**STAFF REPORT**  
**CITY OF BEVERLY HILLS**

**For the Design Review Commission  
Meeting of September 2, 2010**

**SUBJECT:** A request for an R-1 Design Review Permit to allow a façade remodel to an existing two-story single-family residence, located in the Central Area of the City, north of Santa Monica Boulevard at **625 North Elm Drive. (PL 101 7220)**

# 625 North Elm Drive

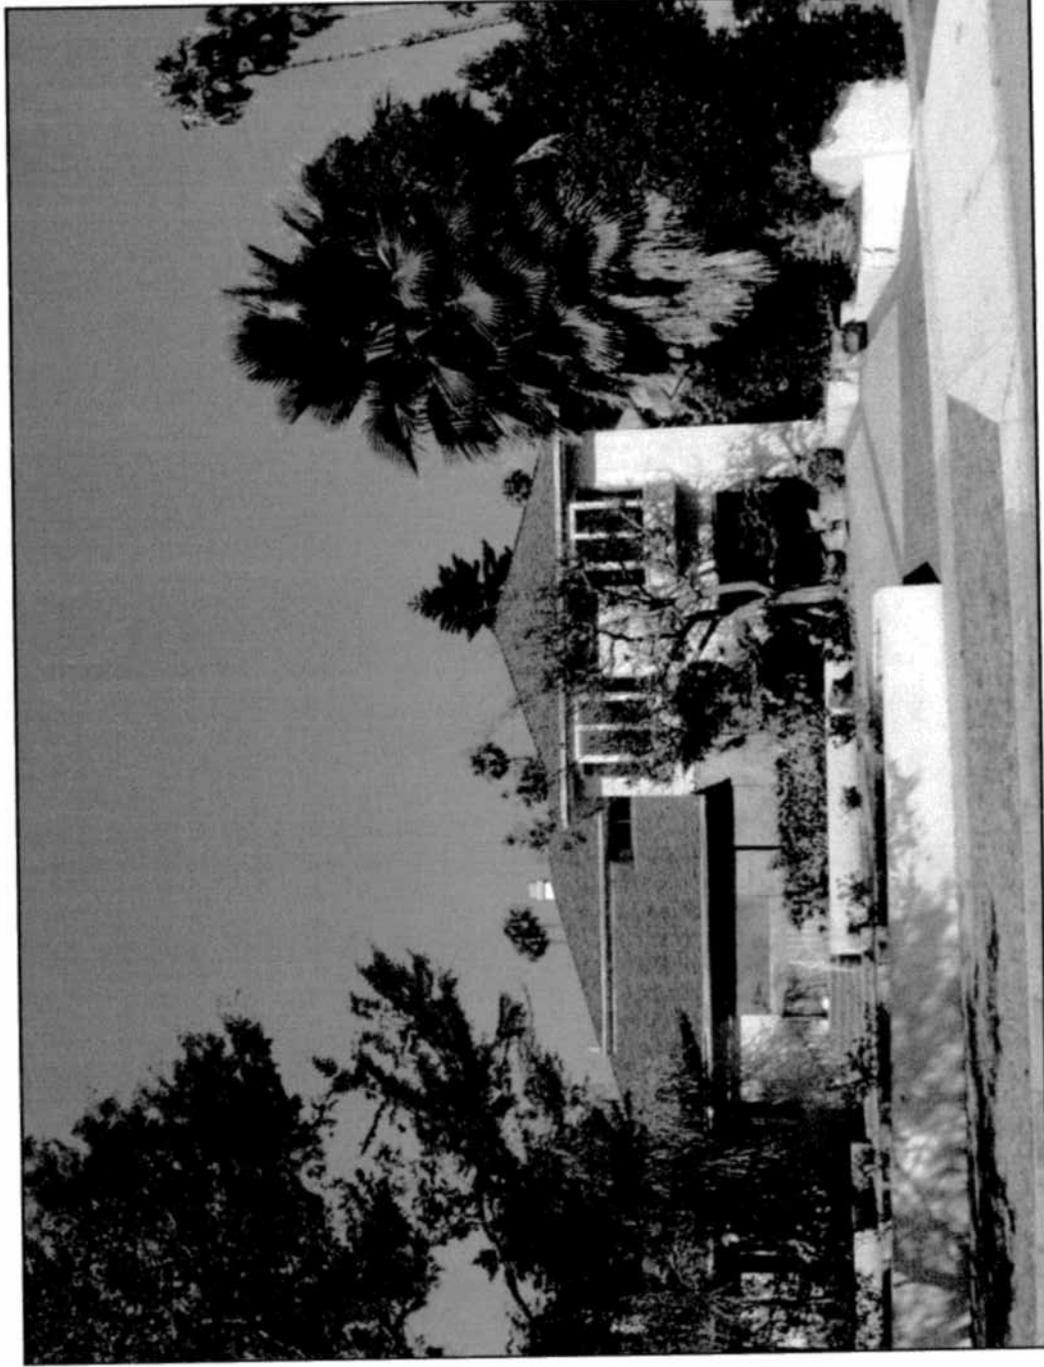
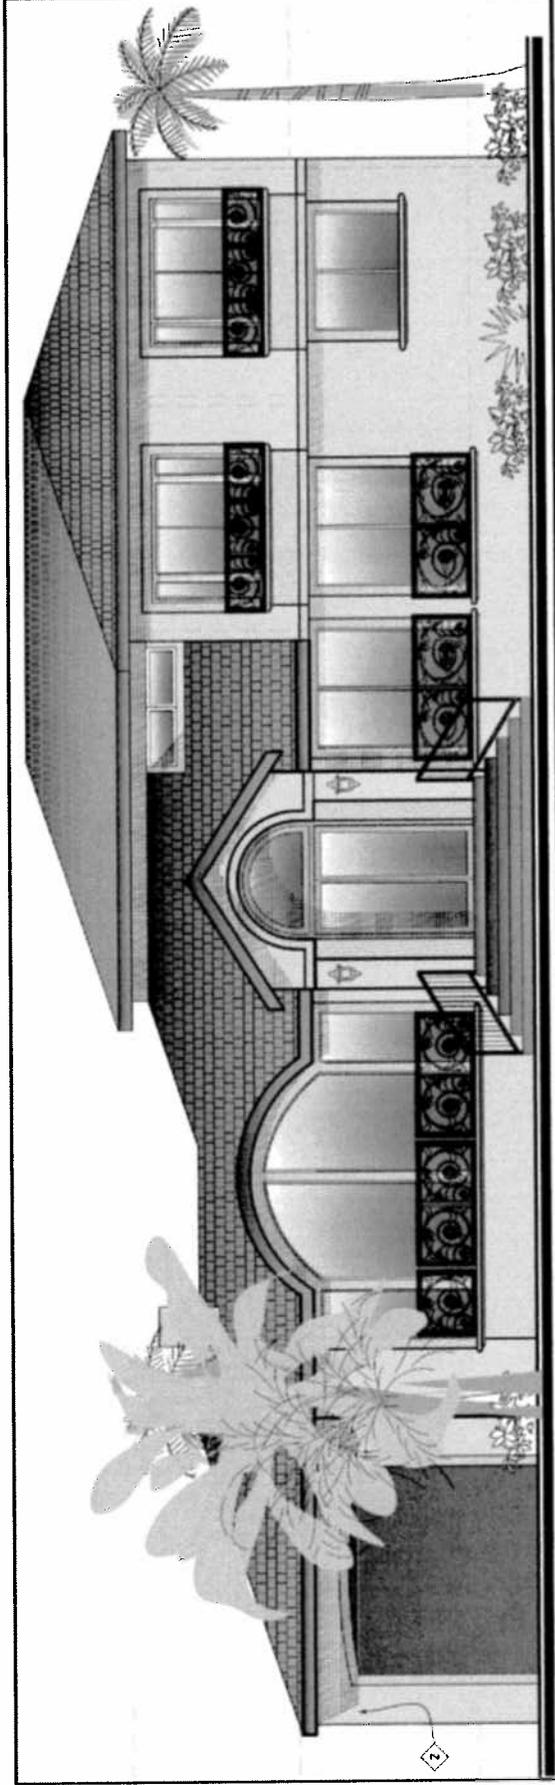
The proposed design generally includes high quality materials; however, "foamstone" molding is considered to be a lower-quality material that may detract from the project's design. Additionally, the design does not appear to conform to a pure architectural style. Because the proposed project has not been designed with a consistent use of quality materials and does not conform to a pure architectural style, it may not be possible to make the finding that the project exhibits an internally compatible design scheme.

The proposed project does not conform to a pure architectural style and the quality of materials used on the project appears to be inconsistent. As a result, the project does not appear to be consistent with surrounding development in the neighborhood. Therefore, it may not be possible to find that the proposed project will enhance the appearance of the neighborhood.

with traditional development associated with the early development of Beverly Hills. Consequently, the project may appear out of place when compared with existing development, which does result in harmony between old and new.

1. All pre-cast moldings should be designed without a foam core, and the thickness of the concrete should be a minimum of ¾" thick.
2. The material sample board shows windows and doors with mullions, but this is not reflected in the drawings. The drawings should be updated to accurately reflect the types of windows and doors selected.
3. The front door depicted on the sample board includes wrought iron detailing; however, this detailing is not reflected on the architectural drawings. The drawings should be updated to accurately reflect all selected detailing.
4. An actual sample of the proposed windows and doors, including framing color, should be provided for the Commission's review.
5. The wrought iron detailing may be too ornate. A simpler alternative should be considered.

Based on the foregoing analysis and pending the information and conclusions that may result from testimony received at the public hearing, as well as Design Review Commission deliberations, staff recommends the Design Review Commission provide the applicant with comments and recommendations, and return the project for restudy. In addition to any comments provided by the Commission, staff recommends that the following modifications be considered when revising the project:
